Product Enhancement for Arjent® S2 and Arjent SL and Vista® lightbars

Federal Signal is pleased to announce more robust mounting feet for the Vista®, Arjent S2 and Arjent SL lightbars.

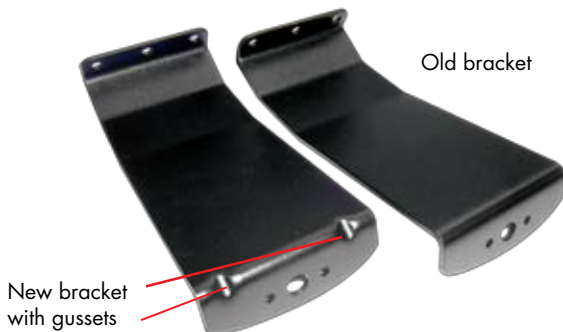
Several changes have been made to the mount design for improved mounting of these lightbars to the vehicles. Hook kits are gusseted to improve the strength of the bracket bend. The new mount foot also incorporates a metal strap for enhanced strength and deter it from bending. Lastly, the durometer, or firmness, of the mounting foot pad has been increased to accommodate for the air pressure.

Hook kits have been gusseted to improve strength

A metal strap has been added to deter mount from bending
